# MANDATORY SERVICE BULLETIN

## NO. MSB 42NG-018/1

#### I.5 Subject

This Service Bulletin prescribes the replacement of the possibly non conforming turbo connector assy D64-8122-20-00 by a conforming part of an improved design.

Picture 1

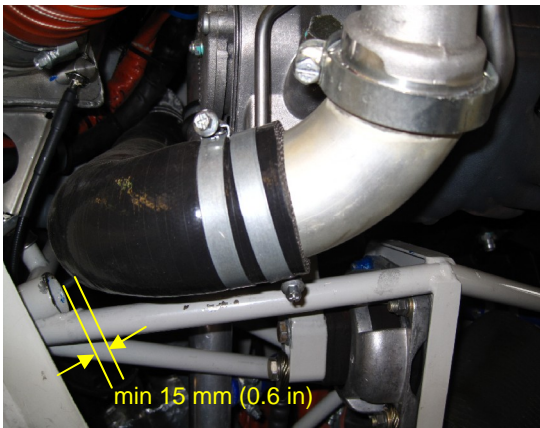
Note: Make sure that the minimum distances shown in pictures 1 and 2 are met.

Drawing 1

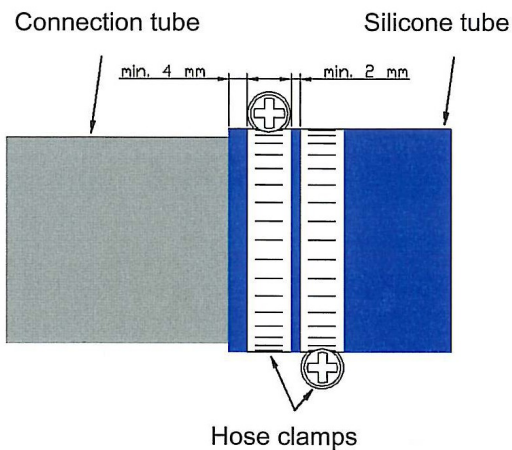
5 Install charged air hose to the turbo connector assy (overlap length min. 45 mm / 1.8 in) with 2 hose clamps TORRO\_60-80\_12\_W1 (refer to drawing 1 and 2). The tightening torque is 5 Nm / 3.7 lb ft.

Note: Mark the min. overlap length of 45 mm / 1.8 in on the tube prior installation

Note: Make sure both hose clamps sit on the tube under the hose.
